**FLATHEAD COUNTY PLANNING AND ZONING OFFICE**  
**CONDITIONAL USE PERMIT REPORT (#FCU-11-01)**  
**CARRIAGE FUNERAL HOLDINGS, INC.**  
**JUNE 21, 2011**

A report to the Flathead County Board of Adjustment regarding a request by Carriage Funeral Holdings, Inc. for a conditional use permit to allow for the construction of a cemetery reception hall building with office space and a crematorium at Glacier Memorial Gardens, an existing cemetery complex located north of Kalispell off of US Highway 93 North.

**Figure 3:** Proposed project location.

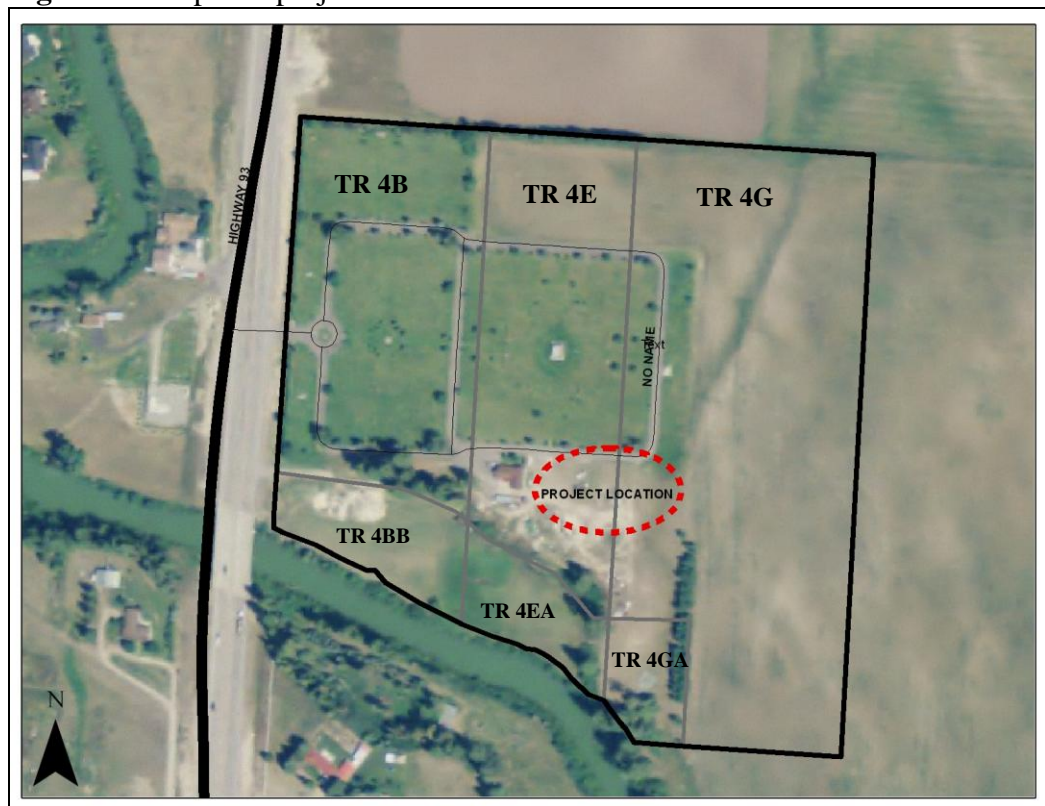
As can be seen in Figure 3 above, the proposed project location spans two tracts of land – Tract 4E and 4G. The existing office building and shed appear to meet the setback requirements for principal and accessory structures located on Tract 4E. However, the proposed office/reception hall and crematorium would be constructed within the applicable setbacks on Tracts 4E and 4G. Because all six tracts are under the same ownership, this situation could easily be dealt with by aggregating the tracts in question to create one parcel; completing a boundary line adjustment between Tracts 4E and 4G to enable the structure to sit entirely on one tract or the other; or by utilizing Section 3.03.020(5) FCZR as it applies to the property. This provision of the zoning regulations allows the Flathead

County Zoning Administrator to formally determine which boundary lines the setback requirements will be assessed from when multiple adjacent parcels are involved in the same use and are retained under one ownership. Any one of these three options would enable the subject properties and proposed use to comply with the bulk and dimensional requirements of the SAG-10 district.

3. The applicant shall complete a boundary line adjustment or lot aggregation between Tracts 4E and 4G to ensure the proposed structure can comply with the applicable setback requirements of the zoning district; as an alternative, the applicant may request a determination by the Zoning Administrator to clearly identify which lot boundaries the setbacks shall be assessed from, in accordance with Section 3.03.020(5) FCZR.

**Figure 6:** Proposed parking and circulation (applicant drawing).

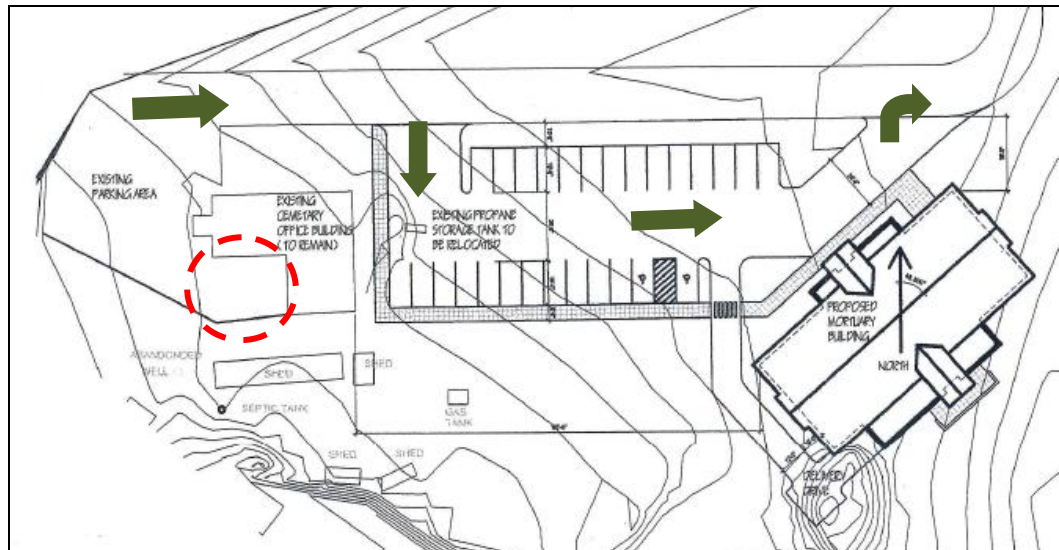
A total of twenty seven (27) parking spaces have been proposed by the applicant, including two (2) handicap parking spaces in accordance with the Americans with Disabilities Act (ADA). As stated in the application, the design of the parking area was intended to accommodate an average-size funeral service; parking for larger services could be accommodated along the internal circulation road serving the cemetery, as necessary. As shown in Figure 6 below, the proposed parking area is located between the existing cemetery office building and the proposed office/reception hall and crematorium, with circulation moving through and around the parking area for maximum efficiency. According to Section 6.04.050 of the Flathead County Zoning Regulations, one parking space is required for every 75 sq. ft. of assembly space for mortuaries (similar to the proposed use). The application and site plan state the assembly space within the proposed building will be a total of 2,000 sq. ft.; based upon this information and the parking requirements imposed, a total of 27 parking space would be required, which the applicant has provided for accordingly.

The remaining 4,000 sq. ft. of the proposed building will be utilized as additional office space and as a crematorium. The Flathead County Zoning Regulations do not provide parking requirements for crematoriums, but do address office space and associated parking needs. According to Section 6.08.030 FCZR, offices require 1 parking space for every 400 sq. ft. of gross floor area or 1 parking space per employee. Correspondence from the applicant indicates there will be one full time employee working out of the proposed office/reception hall and crematorium building; two additional employees will continue to work from the existing office building. Upon visit to the site, there appeared to be a small parking area to the immediate west of the existing office building (shown circled in red in Figure 6 above). A total of three parking spaces for employees of the two buildings will be required to be made available onsite, and shall be located to the west of the existing office building or as an expansion of the proposed parking area shown above.

5. A minimum of 30 parking spaces shall be set aside on the subject property to accommodate employee and visitor traffic generated by the proposed office/reception hall and crematorium, in accordance with applicable zoning regulations [FCZR Section(s) 6.04.050 and 6.08.030].
